Historic Architectural Review Commission Staff Report for Item 13

Application Number: H2022-0020

Address: 218 Simonton Street

Construction of a new two-story residence on vacant lot #3. New accessory structure, swimming pool and site improvements.

2 PROPOSED SITE PLAN
 SCALE: 1/8" = 1'-0" [ROTATED] GRAPHIC SCALE: 1/8" = 1'-0"

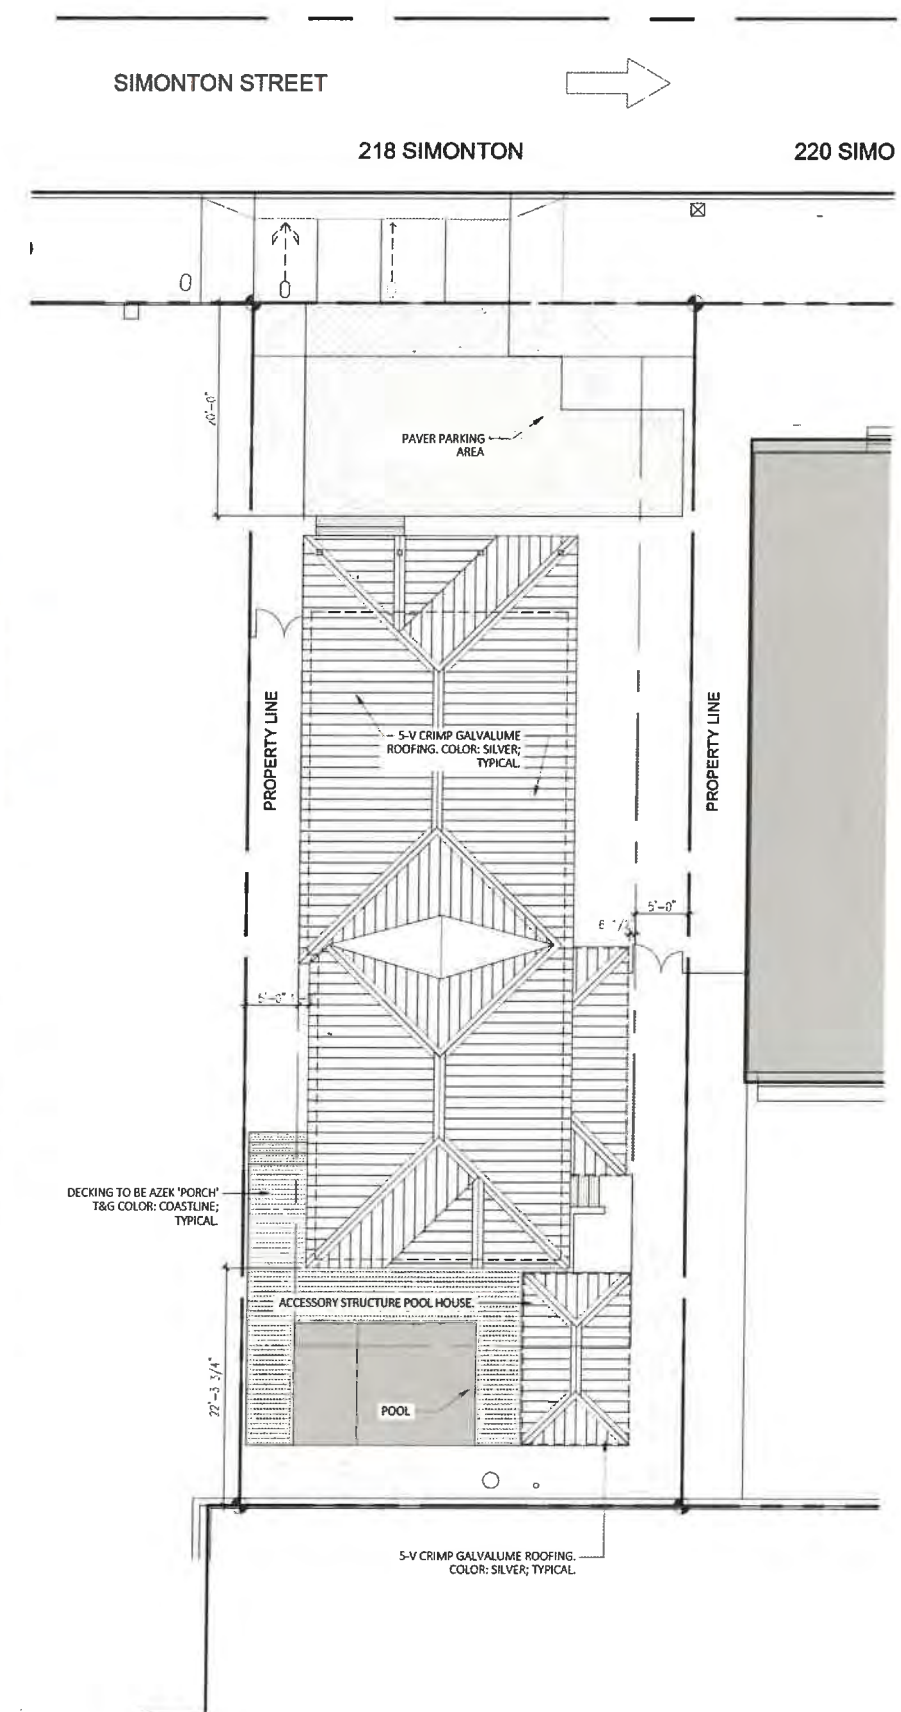
It is staff's opinion that the new buildings conform with cited guidelines as well as the pool. Staff has concerns about the width of the proposed driveway, location, and dimensions of the paved parking area as it will be in front of the house. Staff finds that the site has enough space for a one car driveway and parking space on the northeast corner of the lot. Staff finds the proposed paint scheme to meet current guidelines.
